CHANGE ORDER NO.: 01

Owner: Effingham County Board of Commissioners
 Engineer: Hussey Gay Bell
 Contractor: Southern Civil, LLC
 Project: Hodgeville Lift Station #4 Improvements
 Contract Name: Hodgeville Lift Station #4 Improvements
 Date Issued: 09/19/2023

Owner's Project No.: ITB 22-105-003
 Engineer's Project No.: 120224450

DRAWING NUMBER
06
06 OF 16

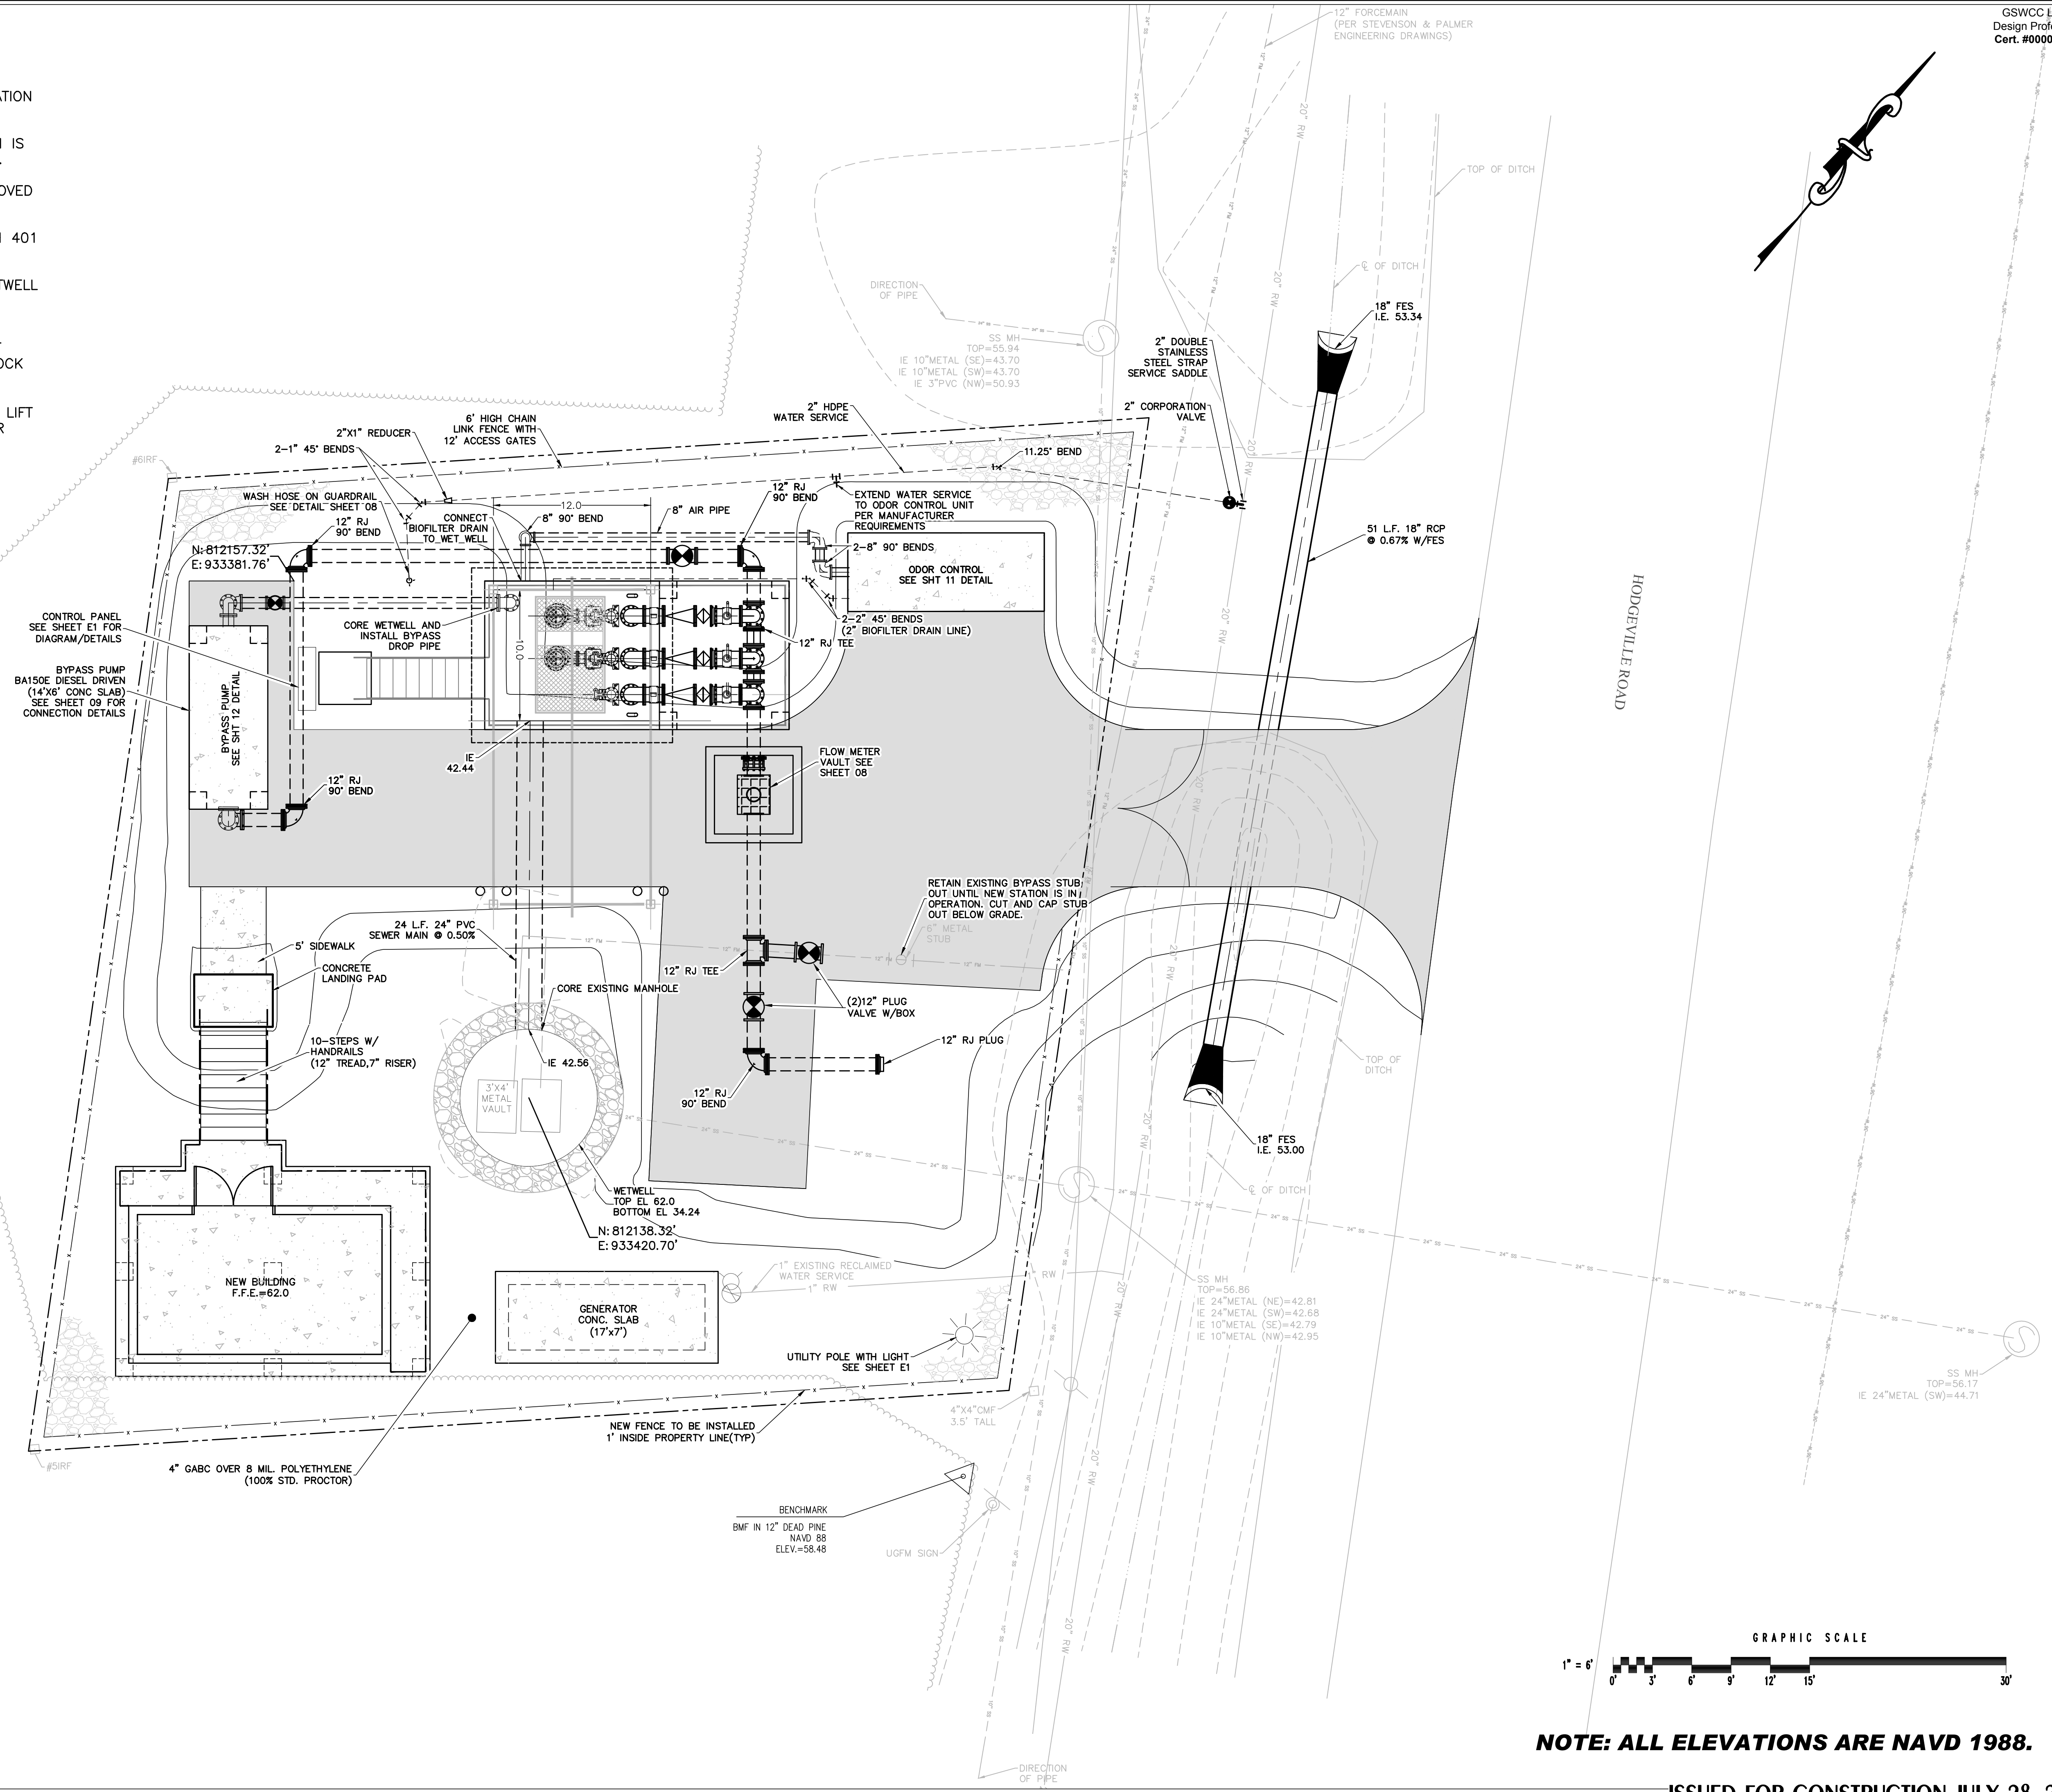
Description: Adjustments to the scope of work include modifications to bypass pump discharge piping, installation of pump three valves and piping, rearrangement of station discharge piping, and adjustments to stub out connection for future force main connection.

- Revised Issued for Construction Plan Sheet 06 marked CO No. 1 – September 11, 2023
- Change Order No. 1 Summary Form
